USB72x6/USB7252 Silicon Errata and Data Sheet Clarification

This document describes known silicon errata for the following USB72x6/USB7252 devices:

- USB7206
- USB7216
- USB7252

FIGURE 2: TYPE-C DISCHARGE WORKAROUND FOR MODULE 3

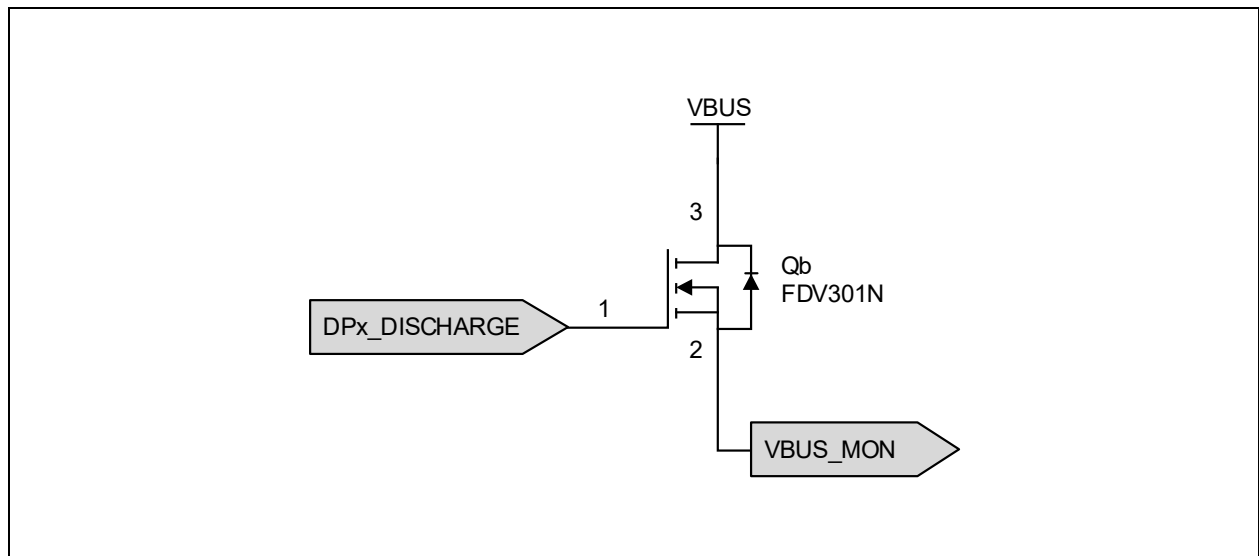
One requirement for USB-IF compliance certification of a system with an exposed Type-C port is the *Port Power On/Off* test. This test is part of the HUBCV suite of *Command Verification* tests for USB 2 devices. As part of this test, the hub must discharge VBUS, and then energize VBUS in response to CLEAR_FEATURE and SET_FEATURE commands from the test host.

Frequently, these ports will be implemented with electrolytic VBUS load capacitors, which retain a small residual charge that is released slowly compared to the timing of the discharge. In such cases, as energy is released from the capacitor the voltage can drift upward slightly after the discharge, which can cross the VBUS_DET threshold for detecting VBUS high. In the sequence of the Port Power On/Off test, this can inhibit subsequent turning on of VBUS in response to commands from the test host and the test fails.

Type C ports that have a large electrolytic capacitor may require this workaround to pass the HUBCV Port Power On/Off test.

In reference designs for USB7216 and USB7252 devices, an N-channel MOSFET with a V_{GS} less than 1.0V is connected between VBUS and VBUS_MON, with gate control from the DISCHARGE signal. This additional component creates an additional current path as the discharge is monitored by VBUS_MON, which biases VBUS_MON higher. This results in discharge to a lower voltage than what is otherwise achieved, and compensates for any residual energy that the capacitor releases after the discharge. At times other than the discharge, the MOSFET is turned off and does not influence VBUS.

No components of the reference design need to be removed; only the MOSFET is added.
